May 17, 2011

Re: Interpretation for SEA 84-D-086-5, Langley School, Tax Map 30-1 ((1)) 42A, 43, and 30-1 ((22)) 2A: Maintenance Building

RE: Interpretation for SEA 84-D-086-5, The Langley School, Tax Map 30-1((1))42A, 43, and 30-1((22))2A

Exhibit 1
A1.01

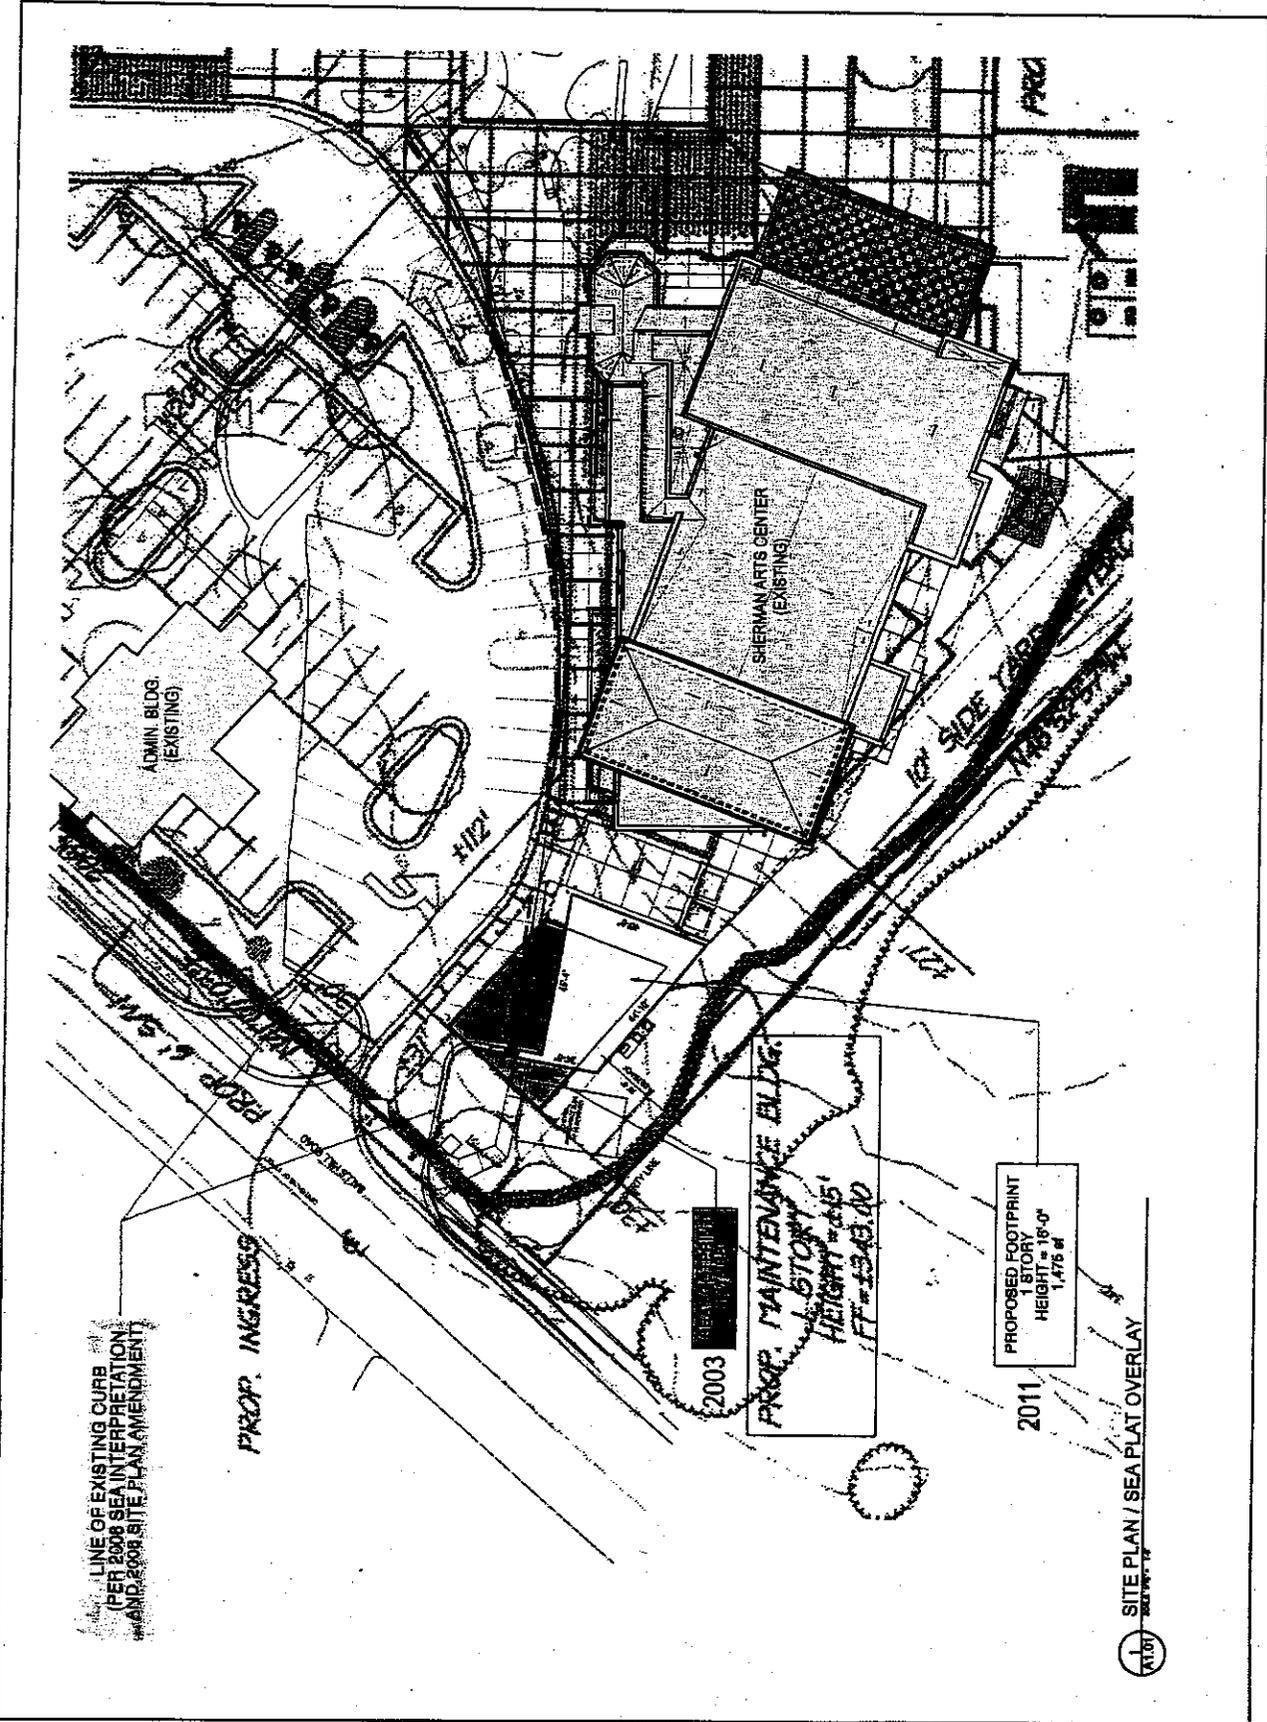
The most recent building to receive site plan approval and be constructed is the Sherman Fine Arts Center shown in gray on *Exhibit 1*. The special exception plat approved in conjunction with SEA 84-D-086-5 showed a maintenance building to the west of the fine arts center. The maintenance building was not dimensioned on the plat but it scales to approximately 1,475 square feet. It was shown with a height of ± 15 feet (one story) and a setback to the side lot line of 30 feet. With the approval of the reconfigured parking area, construction of the maintenance building as shown on the

SEA plat is impossible. This is depicted on *Exhibit 1*. The location of the maintenance building as shown on the SEA plat is in orange on the exhibit and overlaps the approved parking reconfiguration.

The Applicant is faced with finding a location for the maintenance building which is in substantial conformance with the location shown on the approved SEA plat since the building cannot be constructed as shown on the SEA plat. The proposed location is shown in tan on *Exhibit 1*. The building is the same size as that approved on the SEA plat but is shifted to the south to accommodate the approved reconfigured parking area. The building is setback the same distance from the reconfigured parking area as the original location was setback from the original parking configuration. The building has shifted slightly toward the Fine Arts building and thus, away from Balls Hill Road.

It is my determination the proposed maintenance building design and location would be in substantial conformance with the SEA Plat and the development conditions provided that full compliance with Development Condition 13 regarding materials, design and notification of the surrounding communities is attained and provided that the maximum approved Gross Floor Area (GFA) for the special exception is not exceeded.

CROSS SECTION - NORTH / SOUTH
W103

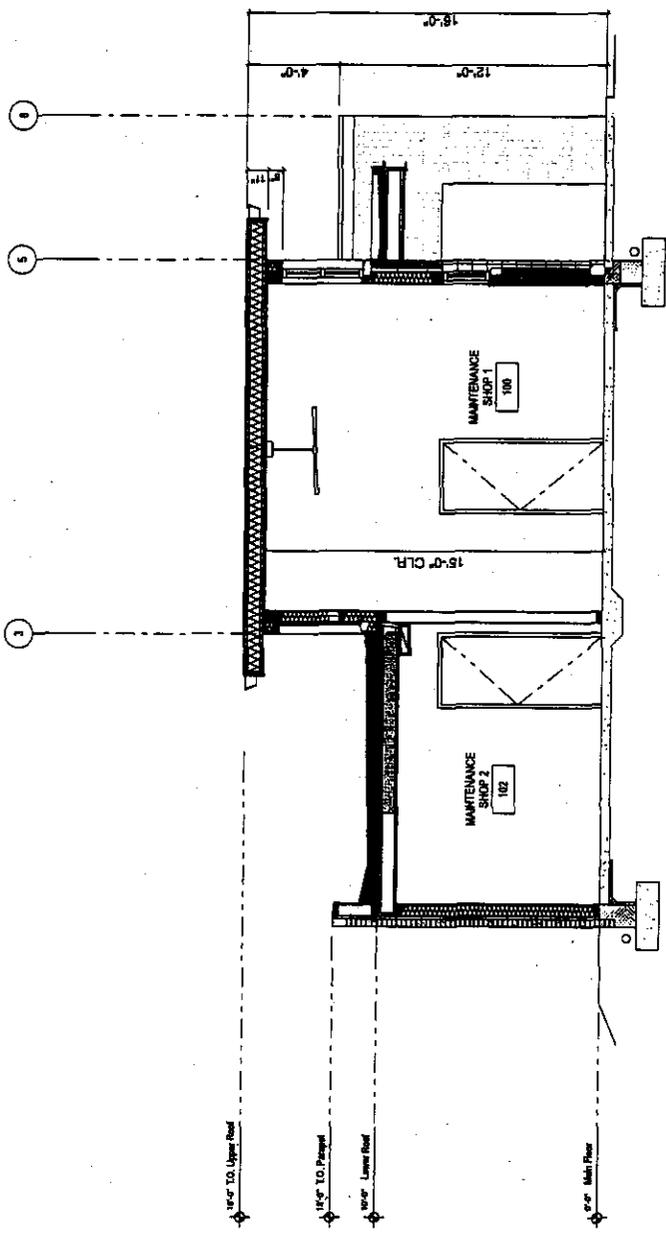
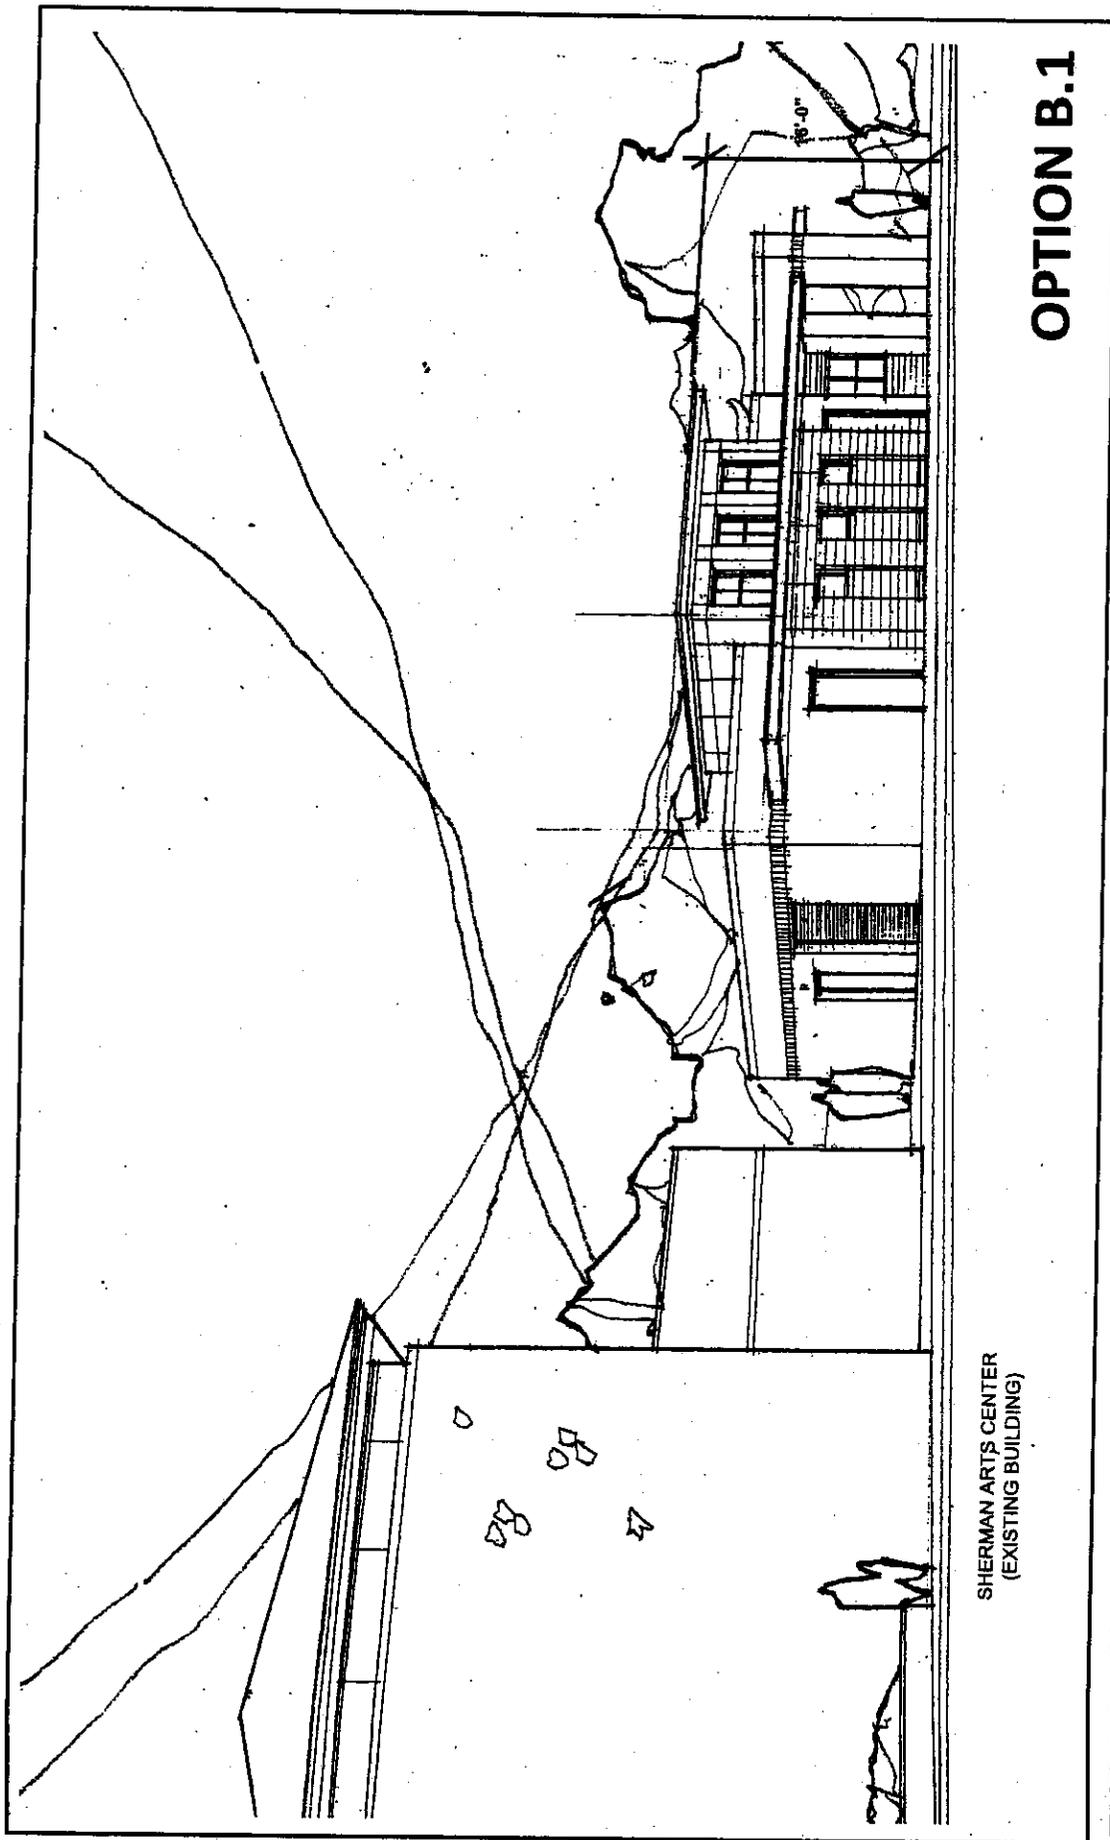
The revised maintenance building is proposed to include 1475 square feet and to be located 42 feet from Balls Hill Road and 26 feet from the southern lot line. The building would be one story with a bank of upper windows and have a maximum height of 16 feet (Exhibit 3). No exterior building materials have been specified.

The three specific elements for which a substantial conformance determination is necessary are building location, building height and setback from the southern lot line. As previously discussed, it is impossible to locate the building as shown on the approved SEA plat because of the approved reconfigured parking, so the building location must shift in a southeastern direction. At the time of the SEA approval, several phases of development were approved and the exact design of the maintenance building had not been developed. The maintenance building has been designed to be compatible with the most recently constructed Fine Arts Center. The building is a single story (see attached floor plan, *Exhibit 2*, and section drawing, *Exhibit 3*) with a bank of upper windows to allow more light into the facility. The majority of the building is 12 feet in height, well below the ± 15 foot maximum dictated by the SEA plat. The small portion of windowed area will be 16 feet in height. This is depicted in a perspective drawing labeled *Exhibit 4* and an elevation drawing labeled *Exhibit 5*. We, therefore, respectfully request a determination that a height of 16 feet for a portion of the building is in substantial conformance with a height limitation of ± 15 feet.
